CHEDBURN • CODD
CONSERVATION ARCHITECTS
Historic Building Consultants

Project	St Lawrence Church Lechlade	
Drawing	North Porch Doors Plan, Elevation & Section	
Stage	RIBA Stage 3 - Planning	
Drawing No.	Scale	Date
1922/048/B	1:50 @ A3	Jan 2023

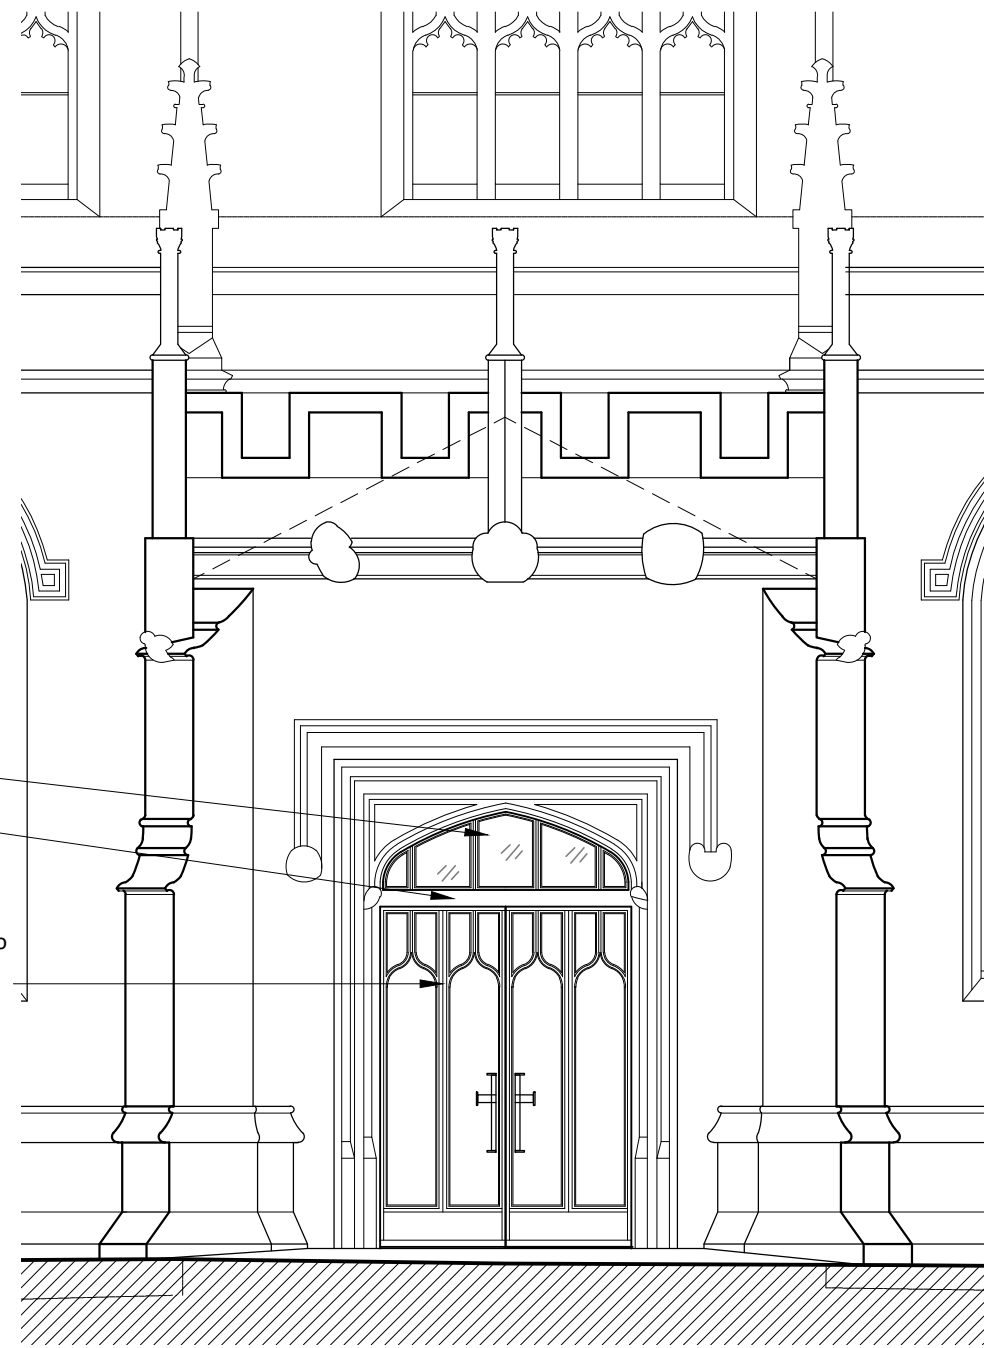
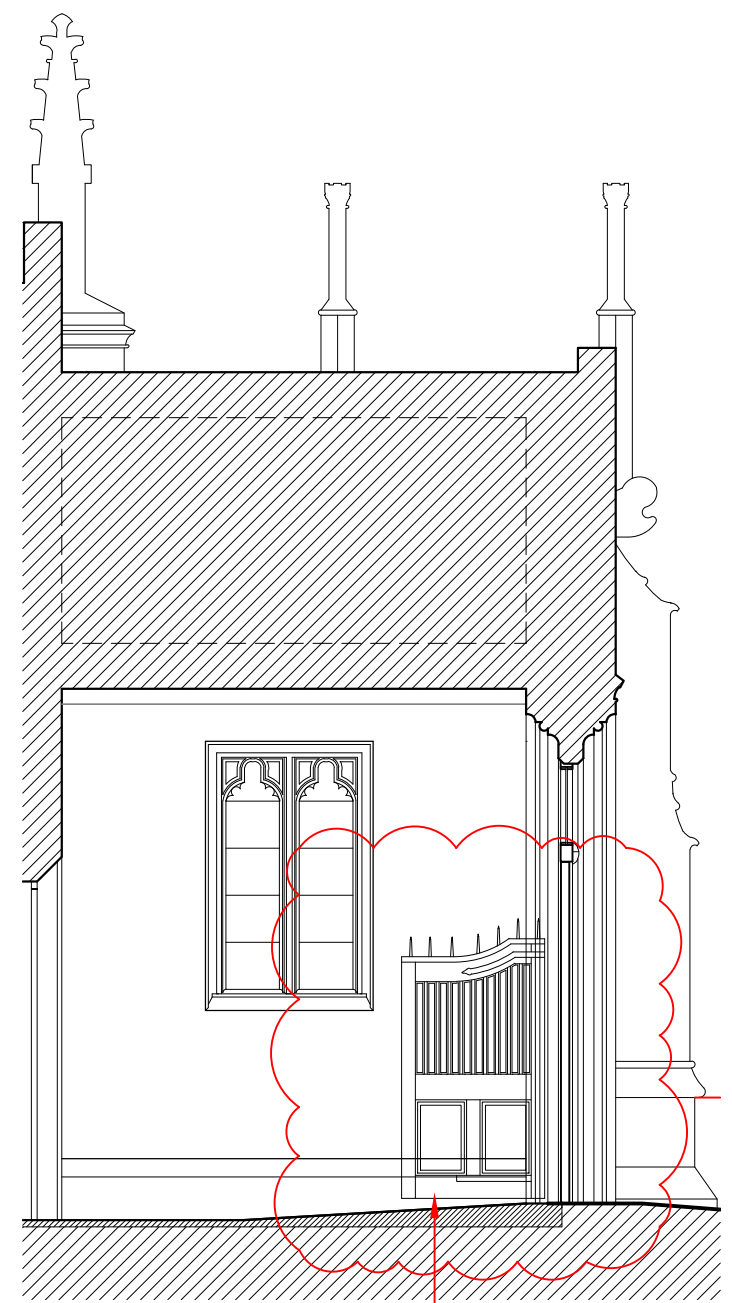
Rev B - Existing timber gates to be removed, restored and relocated inside arch behind the swing of new doors

Rev B - existing gates removed, restored and relocated inside arch behind the swing of new doors

B | 1st Sept Revision to proposed relocation of gates within arched opening of north porch, following discussions with HE and CDC
A | 9th Aug Alterations to existing gates and proposed doors to North Porch following discussions with the Planning Officer

Replacement traditional solid timber boarded doors to be fitted within the arched opening with glazed fanlight above.

Oak framed fanlight over
Oak transom
Oak frame and mouldings to new door leaves to reflect existing window tracery design
